Technical Service Bulletin: tsb100713

New Thermostat Housing

This Technical Service Bulletin introduces a new thermostat housing, Part Number 4924516, for the QSK60 Series Engines. The new thermostat housing improves accessibility to the thermostats and increased coolant flow.

Figure 1, New Thermostat Housing.

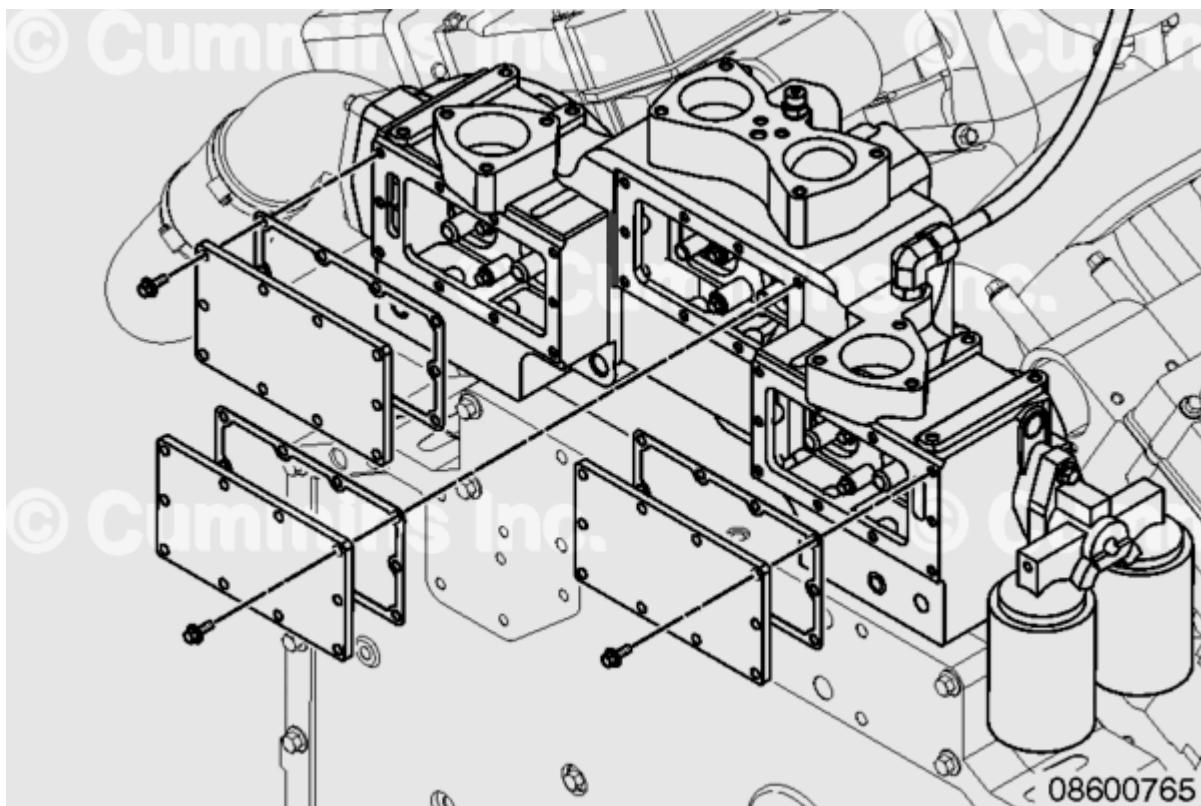
The new thermostat housing mounts in the same manner as the old thermostat housing. Engine Serial Number (ESN) first for the new thermostat housing is 33157500. See Figure 1 for the new thermostat housing.

When upgrading from the old thermostat housing to the new thermostat housing, Part Number 4924516, additional hardware is required due to the increased water transfer tube size.
